CITY OF LA VISTA
MAYOR AND CITY COUNCIL REPORT
JULY 5, 2023 AGENDA

Subject:	Type:	Submitted By:
APPLICATION FOR A PUD SITE PLAN – LOT 2 MAYFAIR 2 ND ADDITION REPLAT THREE AND LOTS 1, 2, AND 3 MAYFAIR 2 ND ADDITION REPLAT SEVEN	RESOLUTION ◆ ORDINANCE RECEIVE/FILE	CHRISTOPHER SOLBERG DEPUTY COMMUNITY DEVELOPMENT DIRECTOR

**CITY OF LA VISTA
PLANNING DIVISION
RECOMMENDATION REPORT**

E. REQUESTED ACTION(S): Approval of a Planned Unit Development (PUD) Site Plan set and ordinance, Conditional Use Permit (CUP), Replat and subdivision agreement.

Exhibit A – Sidewalk Additions

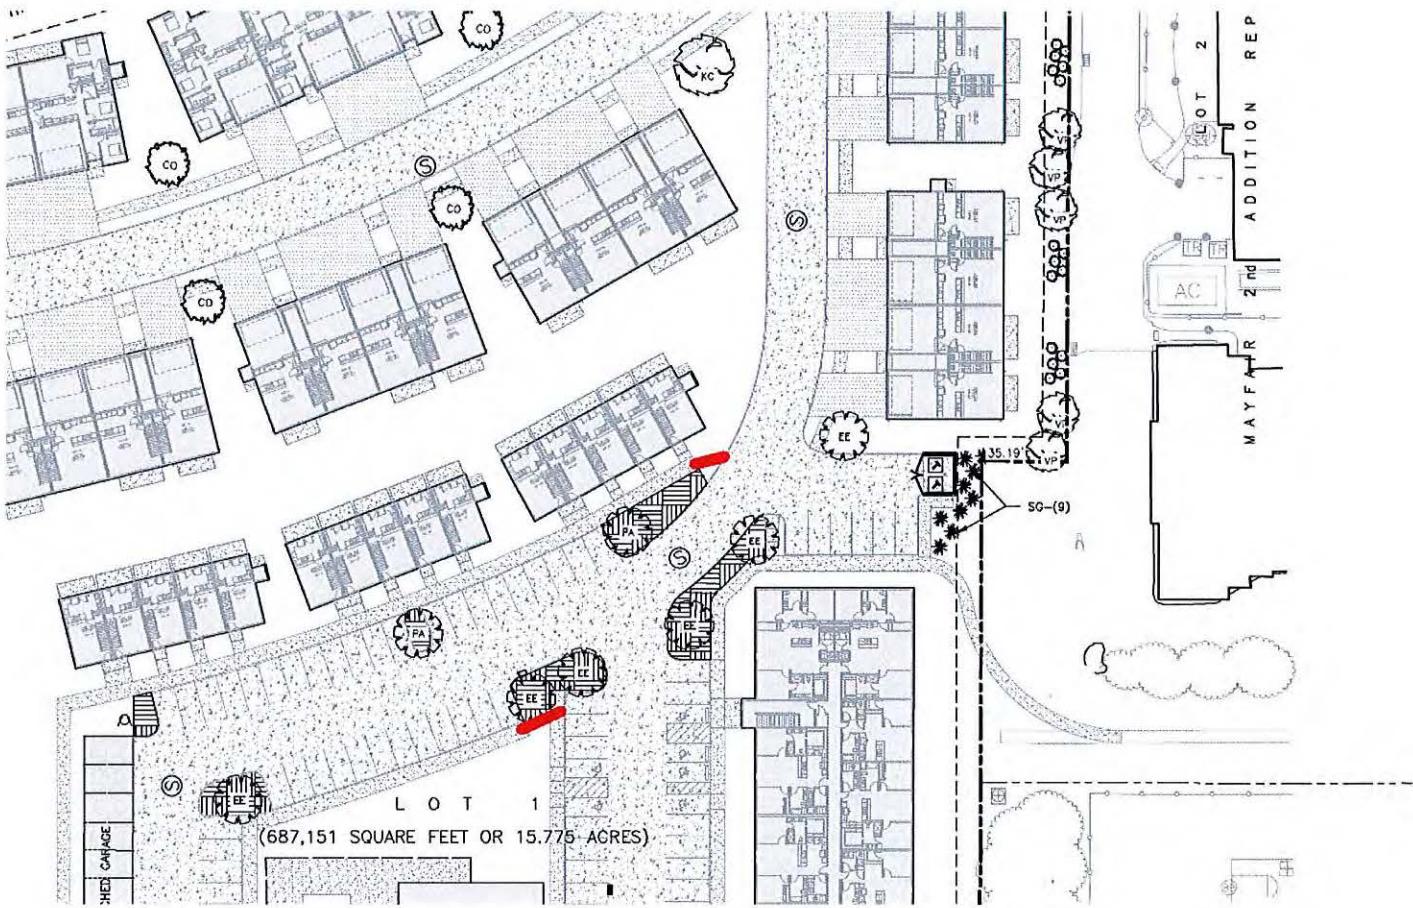
20. Zoning Ordinance Section 5.15.04.07 and 5.15.04.16 - Proper pedestrian access shall be provided between each building within the planned unit development. Sidewalks will be required along each side of the road(s) throughout the development, not just on one side. This sidewalk access should be continued to the north access point near Brentwood Drive as well.

Additional sidewalks have been added on both sides of the street to provide each unit with sidewalk access. The sidewalk has been extended to the access point with Lot 2, Mayfair 2nd Addition Replat 5.

Sidewalks have been added per Exhibit A.
